ARCHITECT'S SUPPLEMENTAL INSTRUCTIONS

Date Issued:	March 5, 2020
Project:	Intermountain Healthcare Tooele Valley Dialysis Clinic Expansion 2356 North 400 East, Suite #102 Tooele, Utah 84074
Architect's Supplemental Instructions:	ASI #1
To:	Saunders Construction 1113 South 500 West Bountiful, Utah 84010

RE: ASI-001 – Department of Health Requests

Electrical ASI #01

EY101

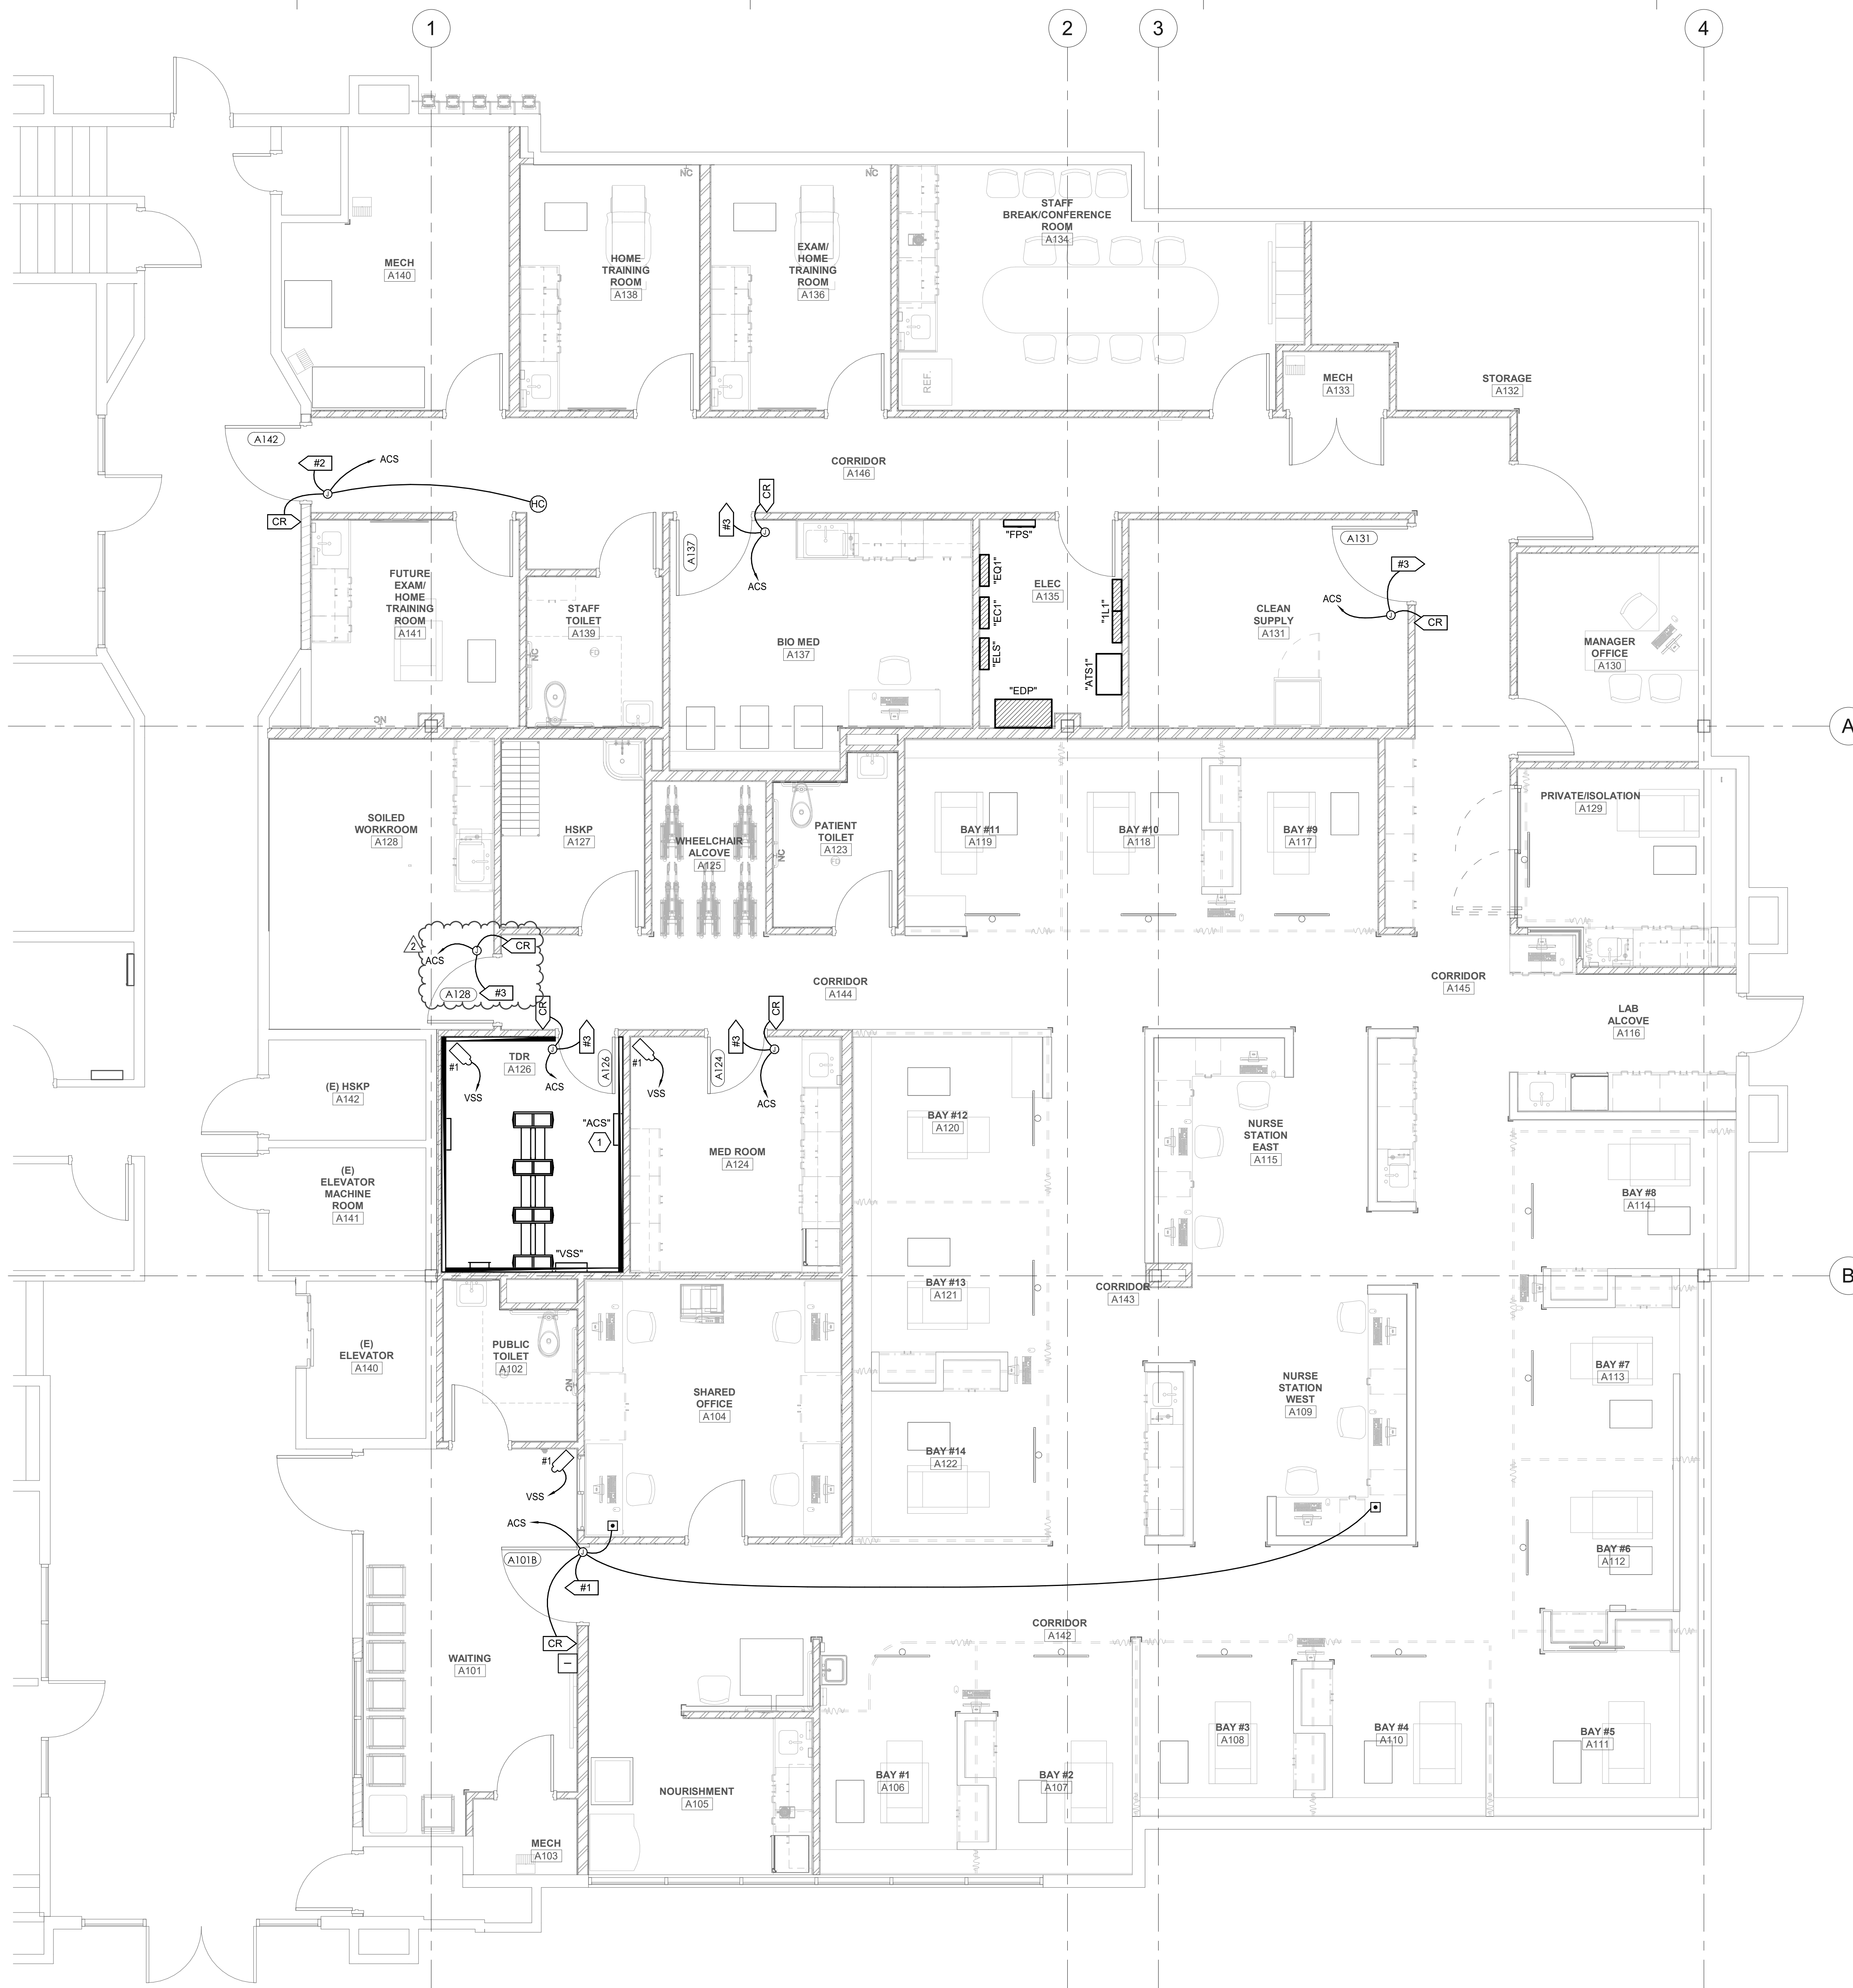
1. Deleted card reader hardware for door A143.
2. Relocated card reader hardware to door A128.

EC101

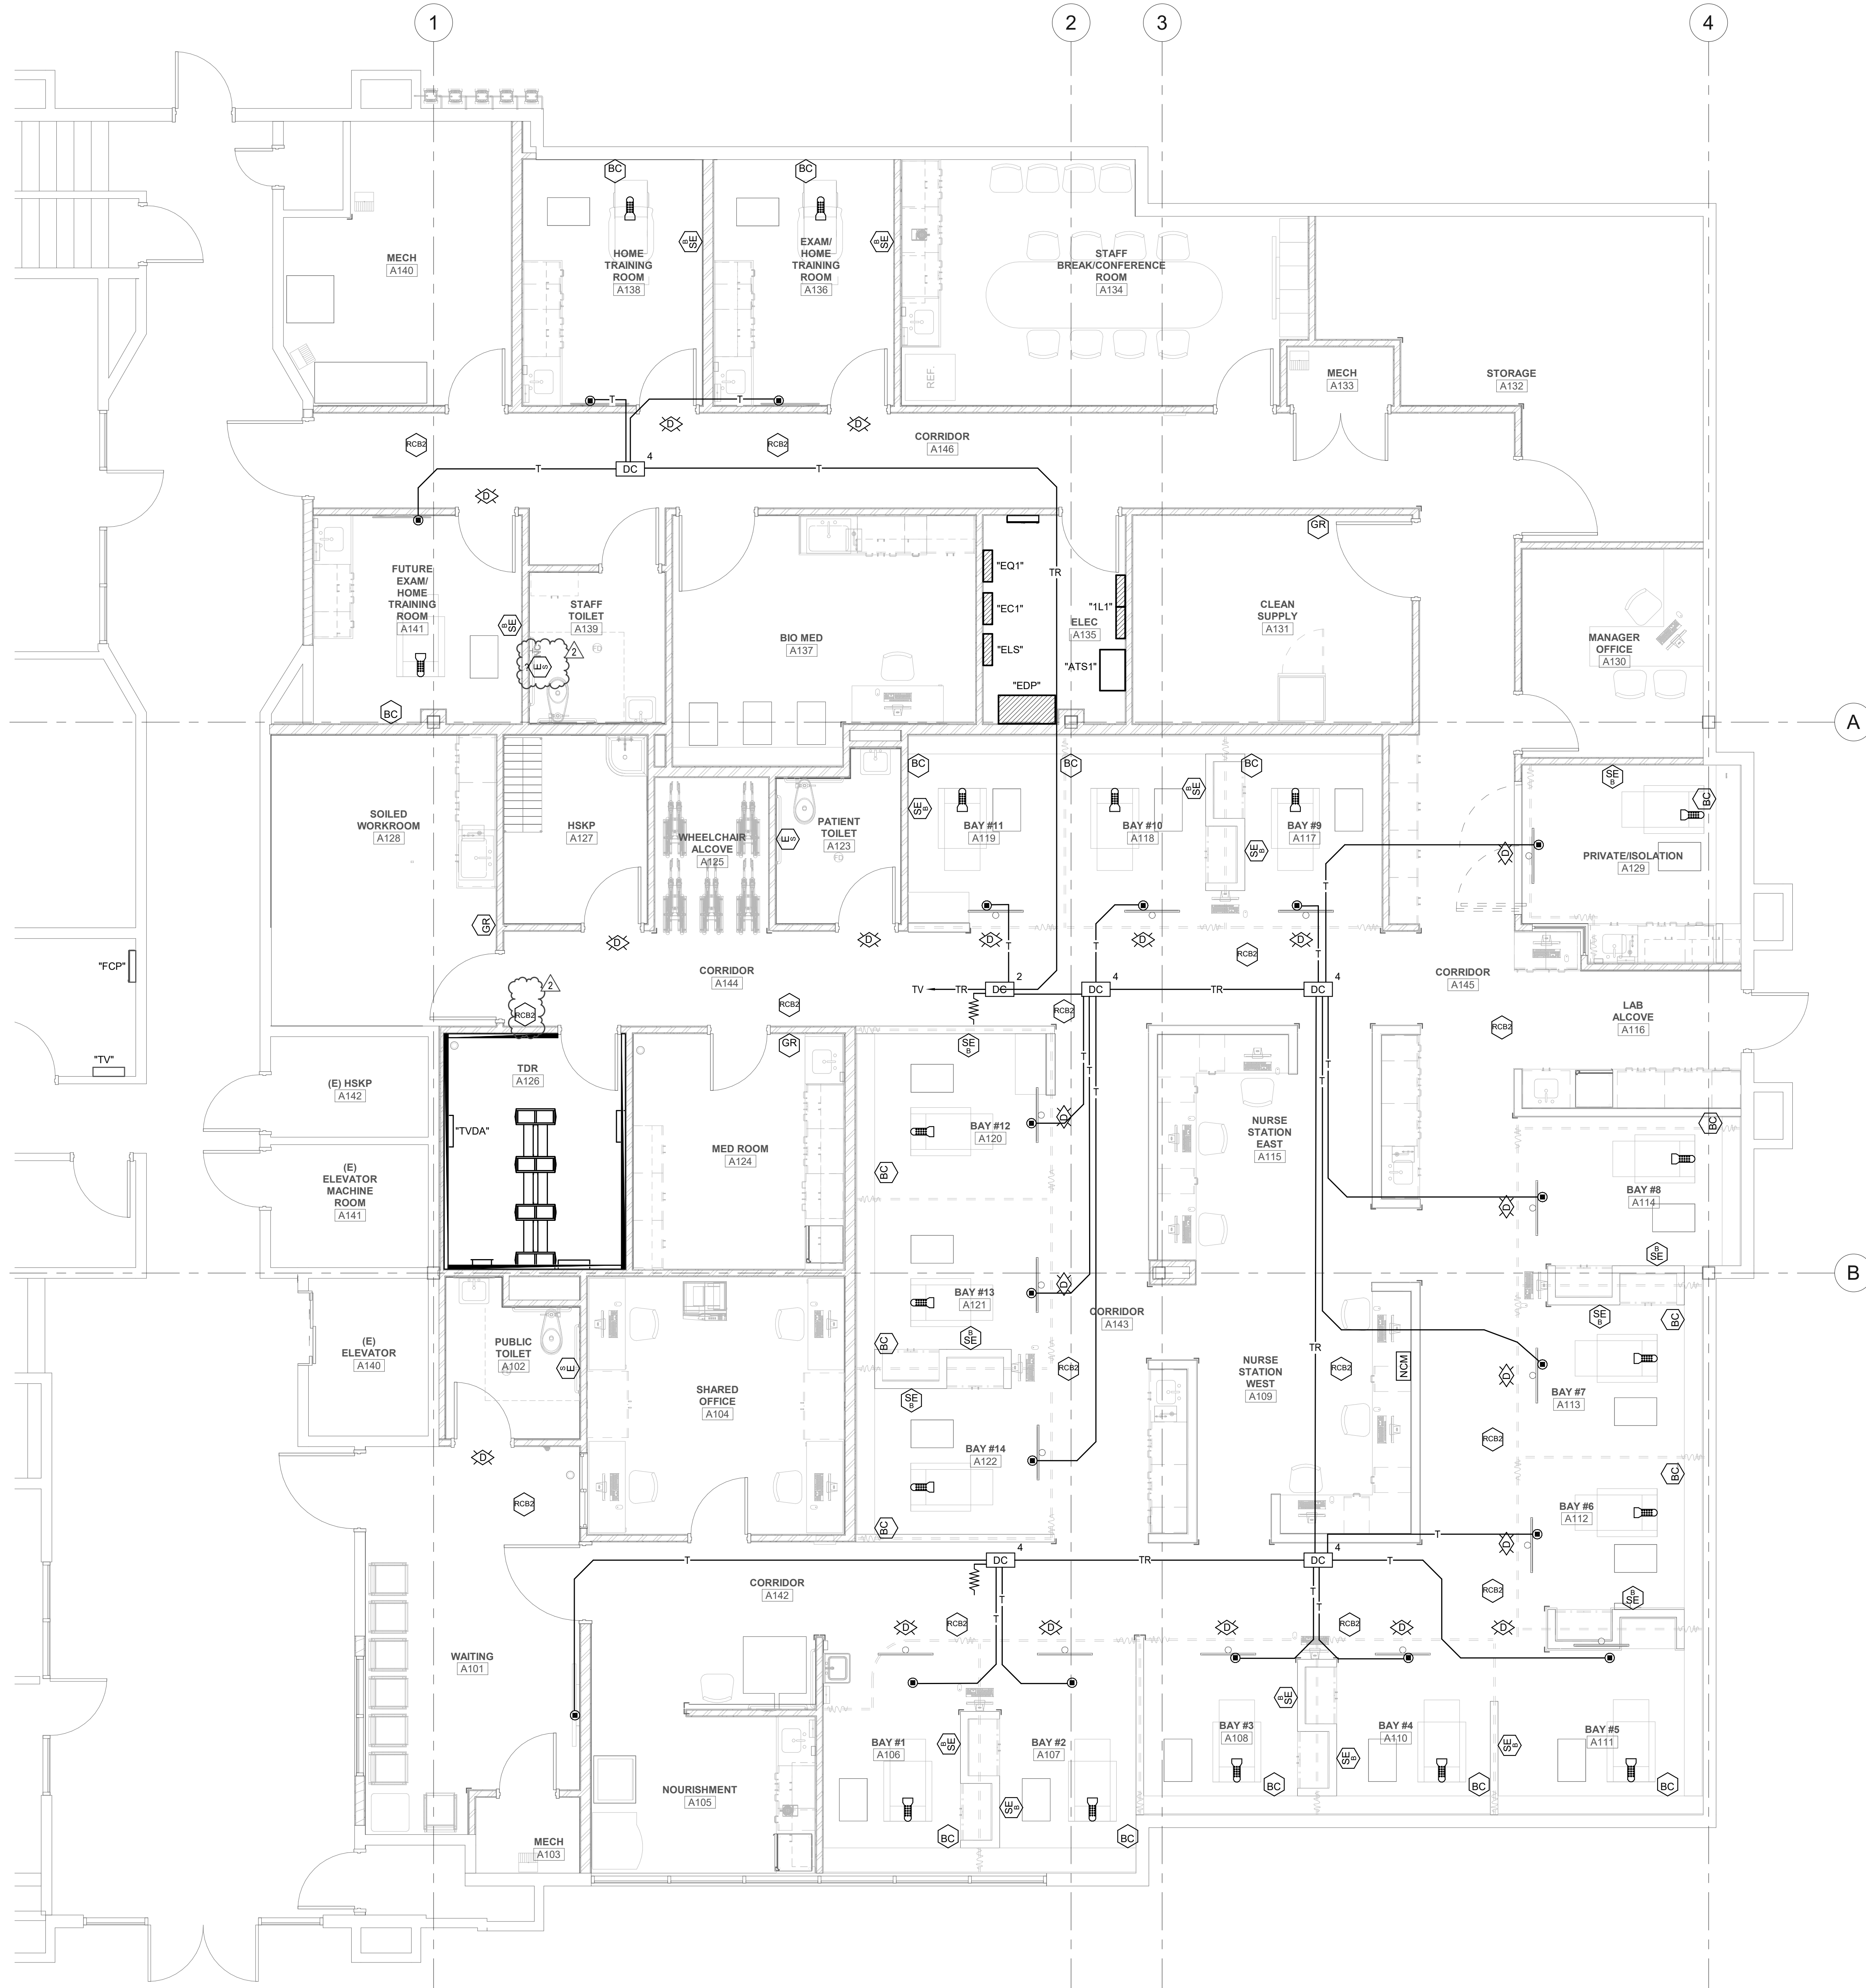
1. Relocated room control board to corridor A144.
2. Relocated nurse call device to Staff Bathroom A139.

**FIRE ALARM
PLAN LEVEL 1**

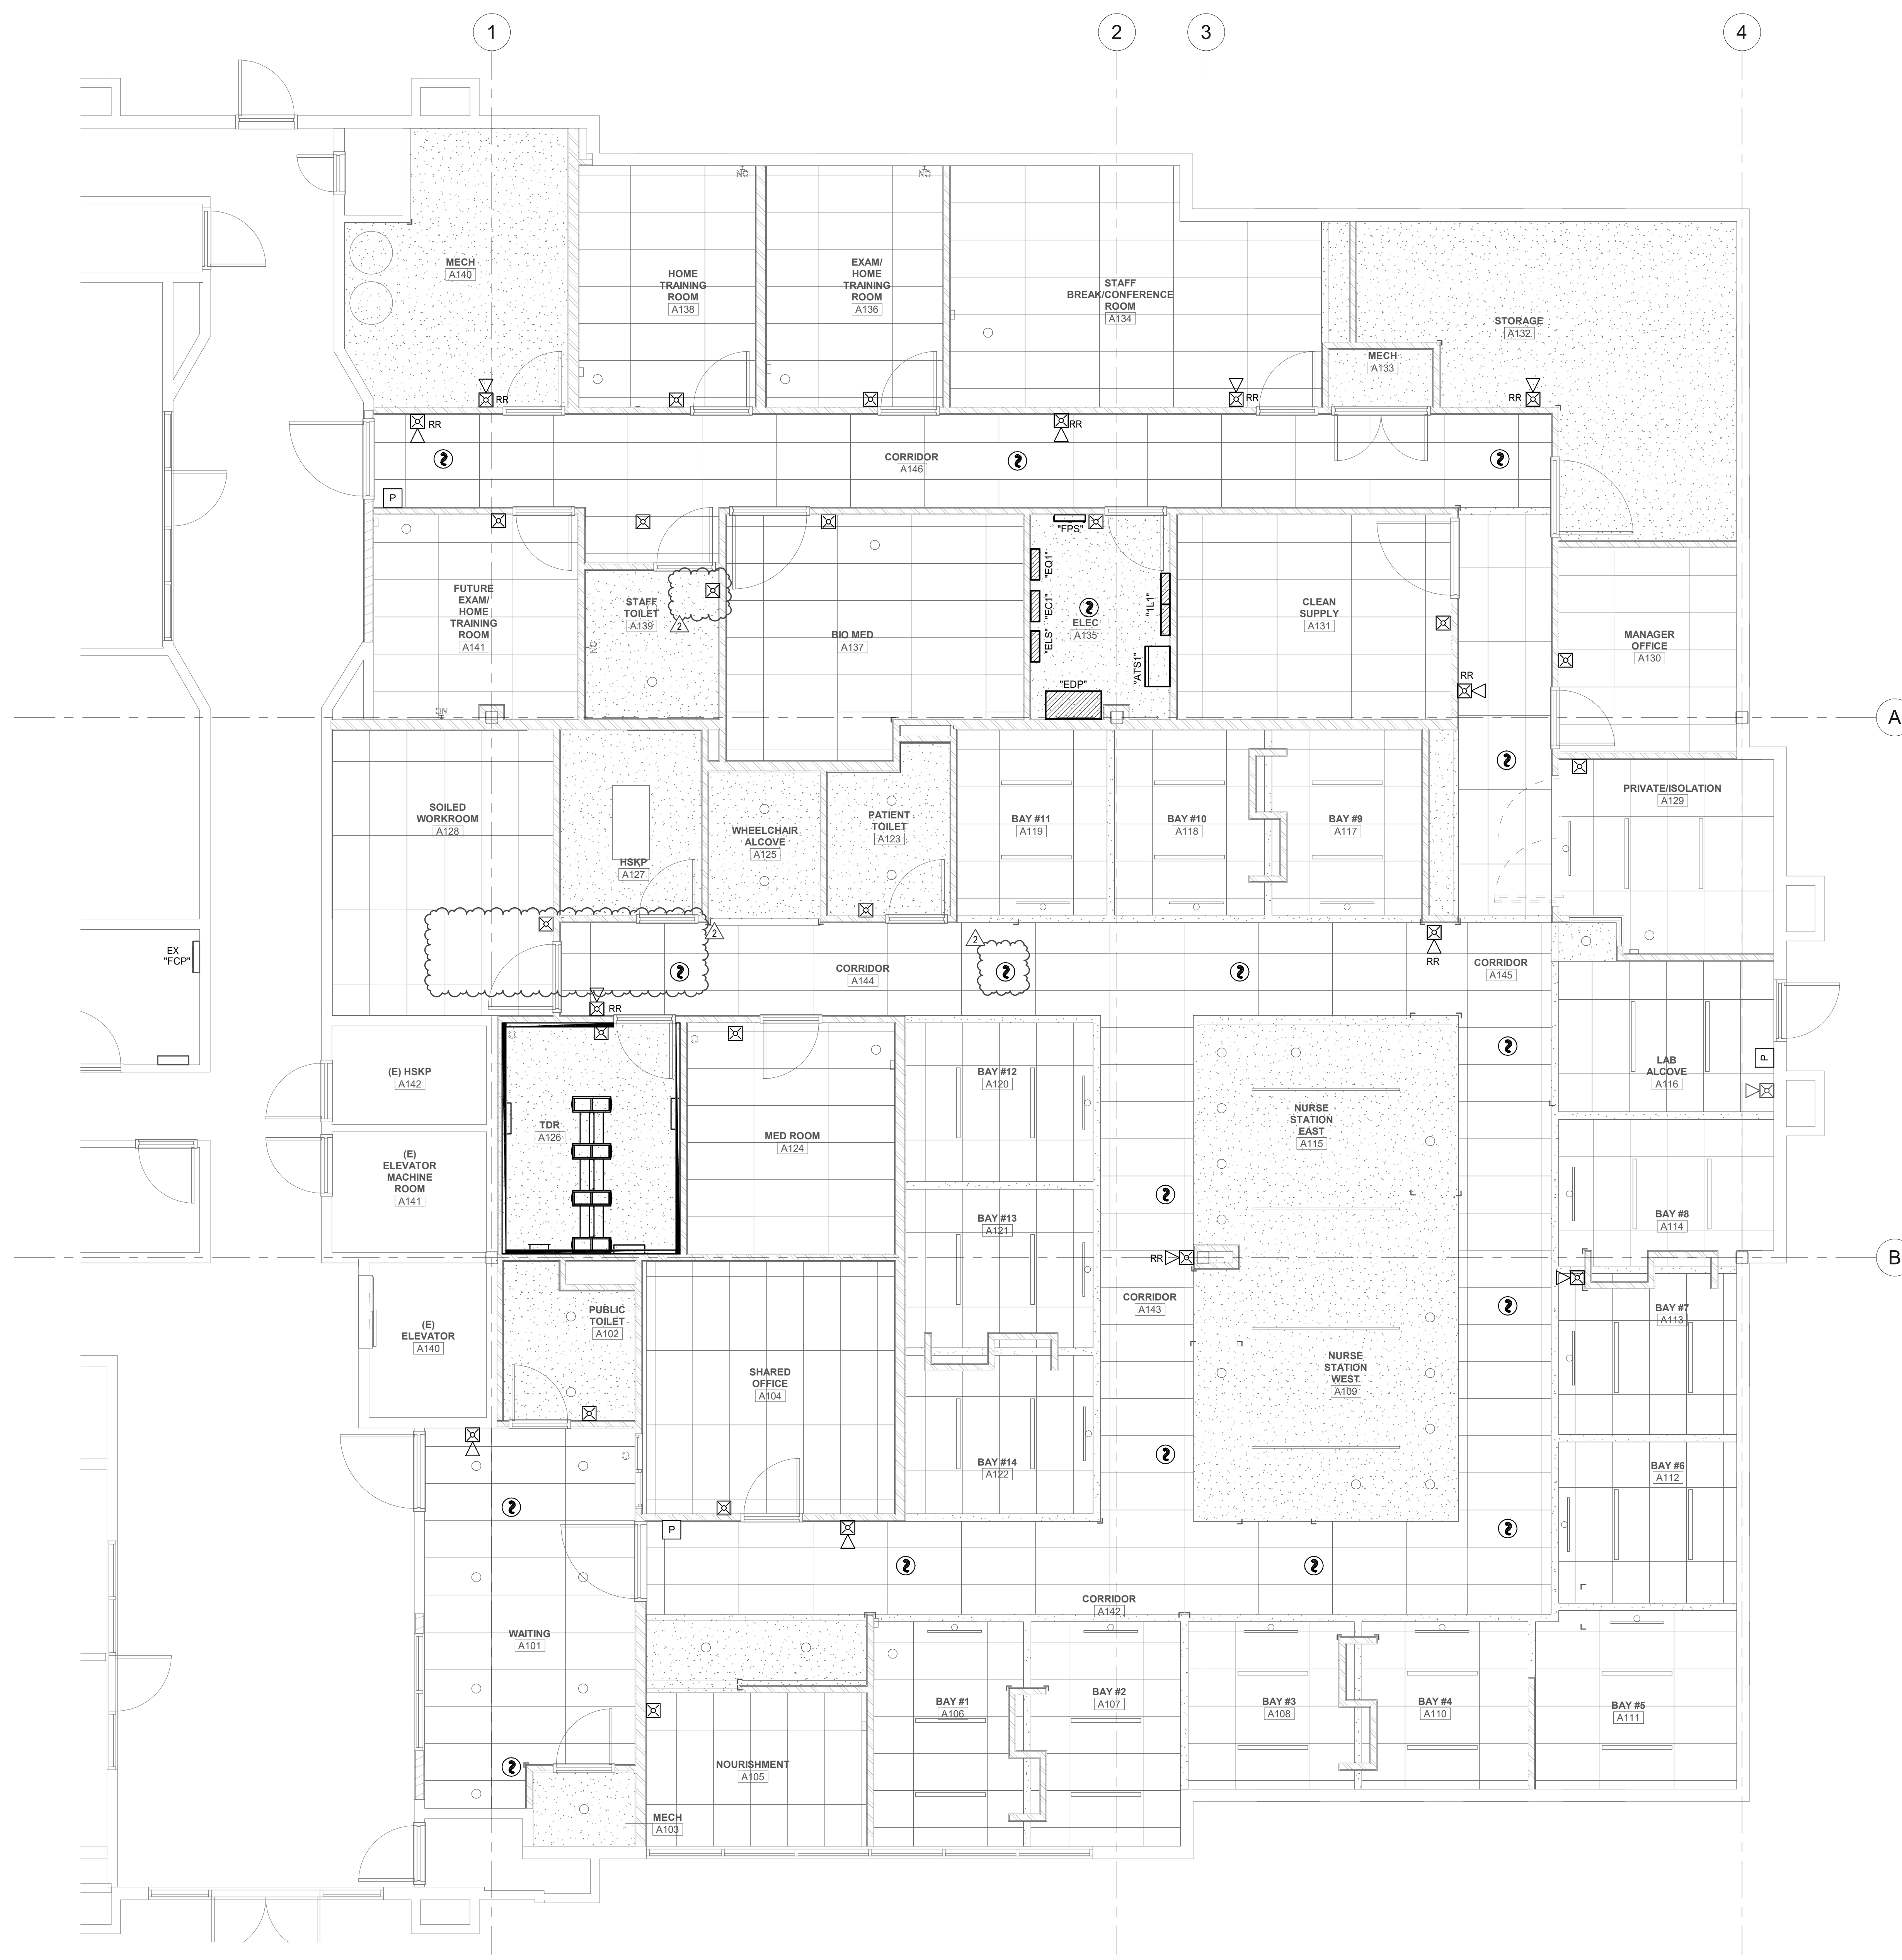
1. Relocated horn strobes to A128 & Staff Bathroom A139.
2. Relocated smoke detectors in corridor A144.
3. Deleted pull station in corridor A144.
